Sedan Range

14-02

TECHNICAL BULLETIN

Air Conditioning Pressure Cutout Switches – Schrader Valves Added – Revised Torque Setting MODEL 1995 MY
Sedan Range
VIN
720001-ON

ILLUSTRATION 1

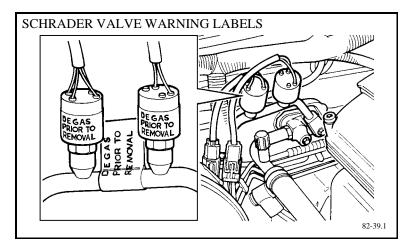
Vehicles within this VIN range may be labeled with a warning, "DEGAS PRIOR TO REMOV-AL." (Illustration 1)

Before removing the pressure switches on these vehicles always depressurize and recover the refrigerant.

• Depressurize both the high and low sides of the refrigerant system using approved R134a recovery equipment.
